REQ. PER UNIT	USED ON			MS-2199	A
	MODEL	ASS'Y. NO.	DATE		
1	GPT-40K	AX-209	4-22-60

ISSUE	ITEM	CHANGED FROM	DATE	CH. NO.	DRAFTS	CHECKER	ENG. APP.	REQ. ITEM	PART NO.	DESCRIPTION	SYMBOL		
										THE TECHNICAL MATERIEL CORP. MAMARONECK, NEW YORK			
									.081 GA.	BRACKET, FEEDTHRU			
									STOCK SIZE	TO COIL			
A	3	TITLE WAS SUPPORT, COIL	7 19 60	2605	Cy	JJE	DB		ALUMINUM				
	2	"B" SLOT WAS 5/16 D.							MATERIAL				
	1	"A" SLOT WAS 13/64 D.							5052-H32				
TOLERANCES			SCALE: FULL										
DEC. DIM. \pm FRAC. DIM. \pm 1/64 ANGULAR DIM. \pm			MAXIMUM ALLOWABLE TOLERANCES HAVE BEEN DETERMINED AND ANY DEVIATIONS WILL BE CAUSE FOR REJECTION: REMOVE ALL BURRS AND SHARP EDGES										
								TYPE & TEMPER	HEAT TREAT. SPEC.	DRAWN	CHECKED	FINAL APPROVAL	
								IRIDITE	S404				
								FINISH & SPEC. NO.	ELEC. DES. APP.	MECH. DES. APP.			
												MS-2199	A

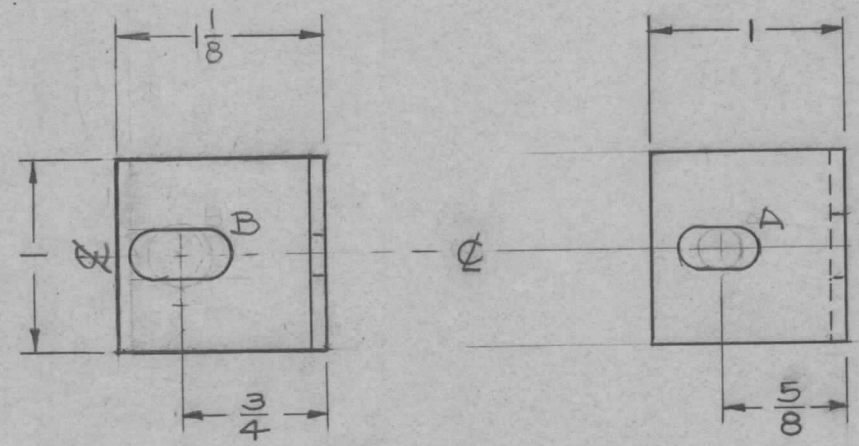
A \checkmark $\frac{13}{64} \times \frac{13}{32}$ SLOT 1 REQ.

B \checkmark $\frac{1}{4} \times \frac{1}{2}$ SLOT 1 REQ.
